# **Flomatic**® Parts & Service Communicator

## Subject: 1028S/W Add-A-Lever

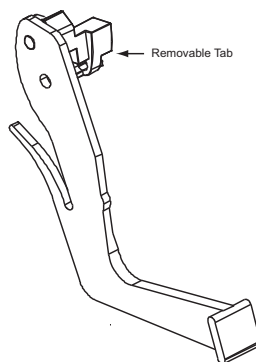
The 1027 Add-A-Lever will no longer be available. The 1028 Add-A-Lever will work with the complete line of Domestic Flomatic post mix beverage-dispensing valves. The 1028 lever replaces the 1027 lever that was used on valves that were equipped with actuators. To adapt the 1028 lever to replace a 1027 lever you must remove the pivoting tab that engages the pallet on a valve not equipped with actuators. Remove the tab with a slight twisting and pulling action. (See Figure Below)
